To: T10 Technical Committee
 From: Rob Elliott, HP (elliott@hp.com)
 Date: 28 March 2006
 Subject: 06-164r0 SAS-2 Require expanders transmit three AIPs

[Figure 1 — Extended primitive sequence](#)

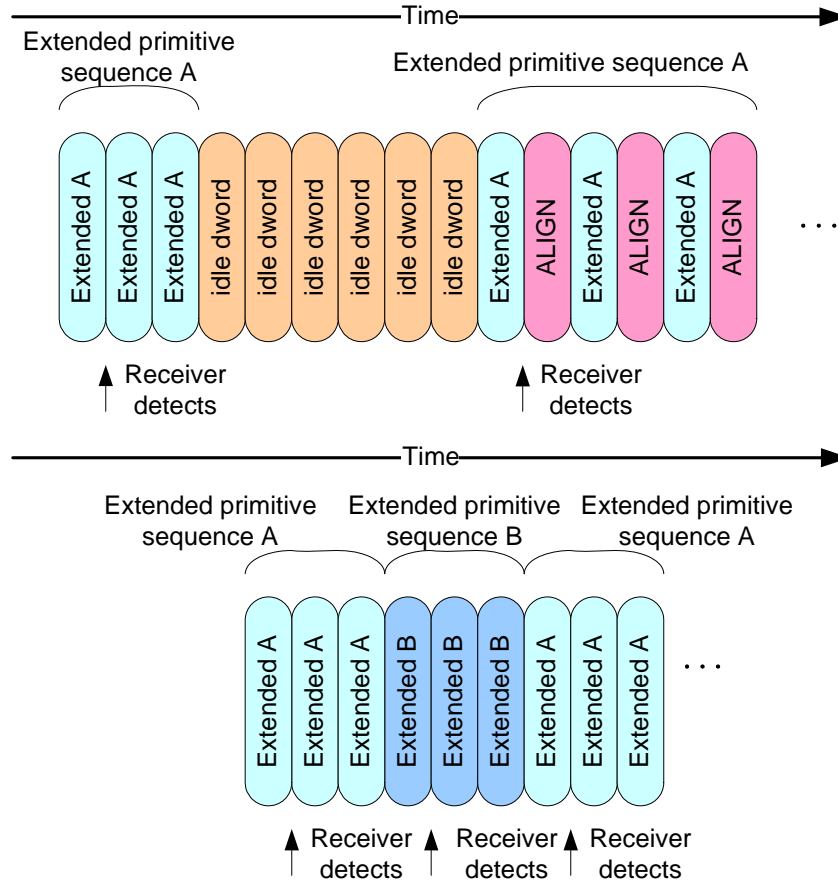
[7.2.4.x Extended primitive sequence](#)

[Primitives that form extended primitive sequences \(e.g., AIP\) shall be transmitted three times consecutively. ALIGNs and NOTIFYs may be sent inside primitive sequences as described in 7.2.4.1.](#)

[A receiver shall detect an extended primitive sequence after the primitive is received one time. After receiving an extended primitive sequence, a receiver shall not detect a second instance of the same extended primitive sequence until it has received three consecutive dwords that are not any of the following:](#)

- [a\) the original primitive; or](#)
- [b\) an ALIGN or NOTIFY.](#)

[Figure 1 shows examples of extended primitive sequences.](#)
